Red Ink Mine Waste Pile #5 Review

An onsite meeting concerning the stability of the Red Ink mine waste pile #5 occurred on October 4th, 2011. The following were in attendance,

FIGURE 1

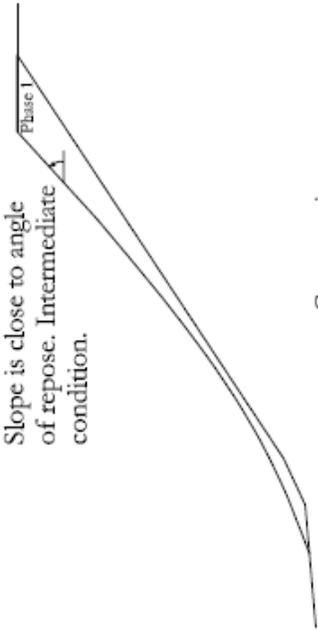
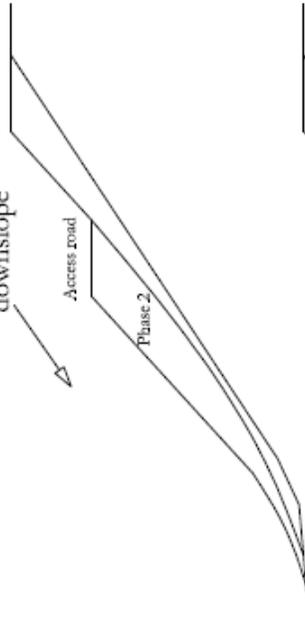
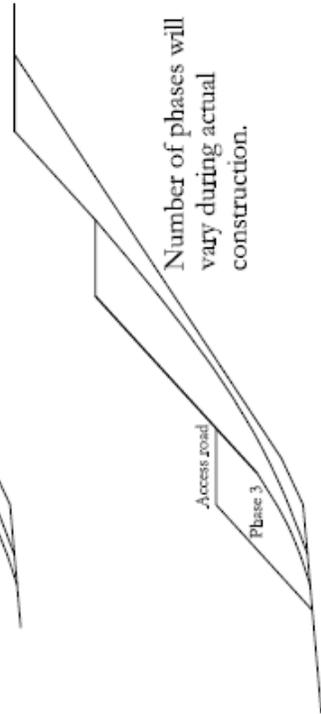
Final grade shall equal stable slope angle specified in Holdrige and Kull report of 33 degrees. Final design details for alternatives depicted is the responsibility of the Operators engineering representative. The construction sequence depicted is interpretive and may not accurately represent the intermediate construction configuration(s). The Operator is responsible for stability of both intermediate and final outslope configurations.

~42 degrees currently.
Slope is close to angle of repose. Intermediate condition.

Micropiles: Shear key or micropiles can be placed at toe to augment global stability of waste dump - particularly during seismic event.

Once stable toe is constructed waste rock shall be placed at an angle less than or equal to the required final outslope angle. Proceed upslope to bench elevation.

Horizontal reinforcing elements allow steeper outslope to be achieved.

Number of phases will vary during actual construction.

33 deg maximum

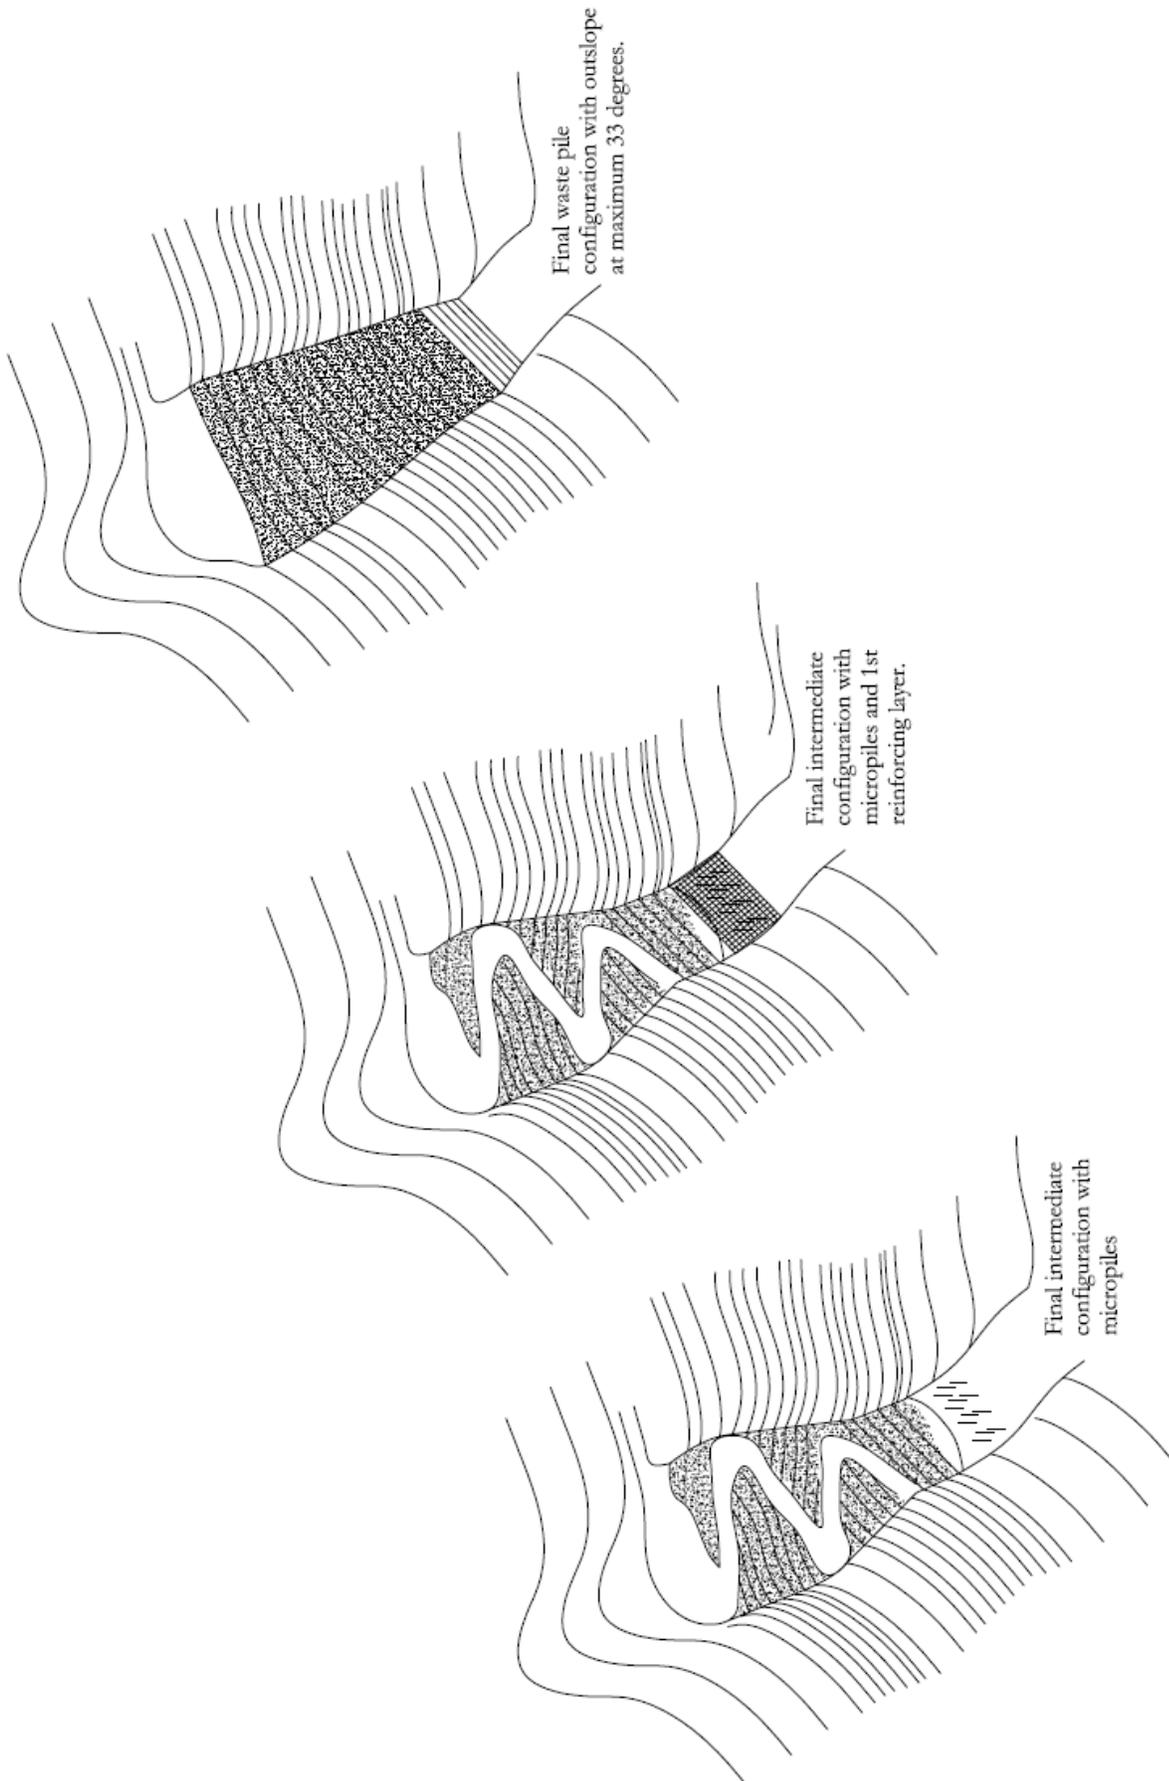
Intermediate configurations of waste pile #5 proposed by the operator have marginal static stability. Though the construction methods proposed to achieve the required final outslope grade (Figures 1 and 2) appear feasible it is the responsibility of the operator and his engineering representative to insure stability during all phases of construction on waste pile #5. Storage on waste pile #5 can be increased with the inclusion of a gravity structure at the toe of the fill – gabion wall, reinforced rock buttress, or similar structure. Global stability of waste pile #5 can be improved by keying in the gravity structure or installing mini/micro piles. Surface water management needs to occur on waste pile #5. A monitoring program on waste piles 2 and 4 needs to be established to develop a functional relationship between slump/landslide movement and precipitation.
